Western Star
Service Bulletin

General Information

The fuses on horizontally-mounted powertrain power distribution modules (PDM) may crack due to vibration. Use the instructions in this bulletin to reduce the level of vibration on the PDM.

Fig. 1, Wrapping the PDM Harness with Electrical Tape

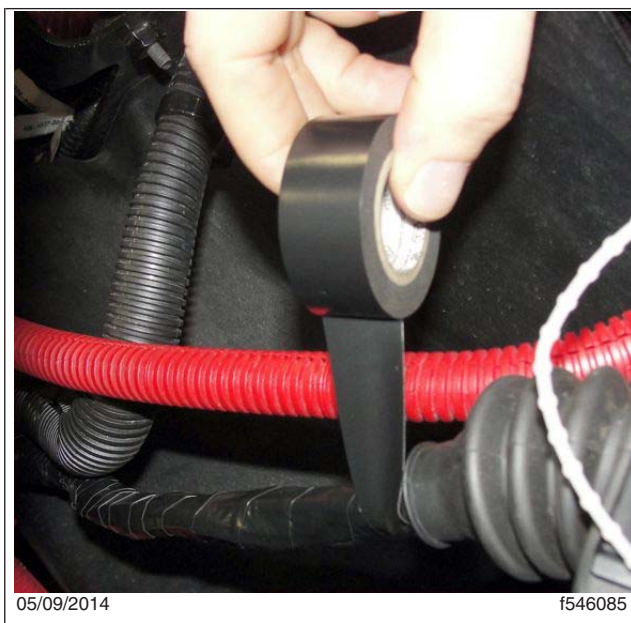
1. Park the vehicle, shut down the engine, and apply the brakes. Chock the tires.
2. Open the hood.
3. Remove the split loom from the PDM harness and discard.
4. Wrap a 6-inch (15-cm) length of the harness with electrical tape, starting at the base. See [Fig. 1](#).

Fig. 2, PDM Harness with a Drip Loop

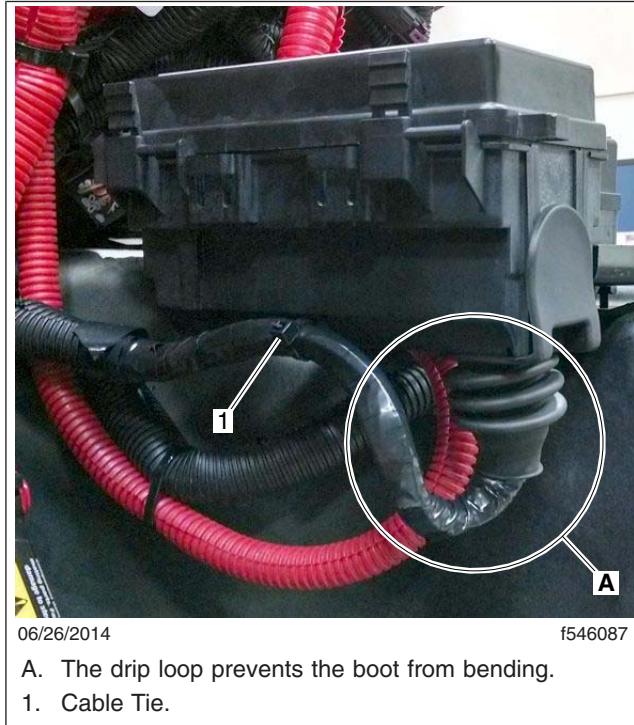
5. Secure the harness to the PDM using a cable tie.
 - 5.1 Feed the cable tie through the opening at the base of the PDM.
 - 5.2 Wrap the cable tie around the harness and attach the ends, but do not tighten.
 - 5.3 Form a drip loop with the harness so that the PDM boot is not bent or pulled by the harness.
 - 5.4 Tighten the cable tie and secure the harness tightly to the base of the PDM. See [Fig. 2](#).
6. Close the hood.
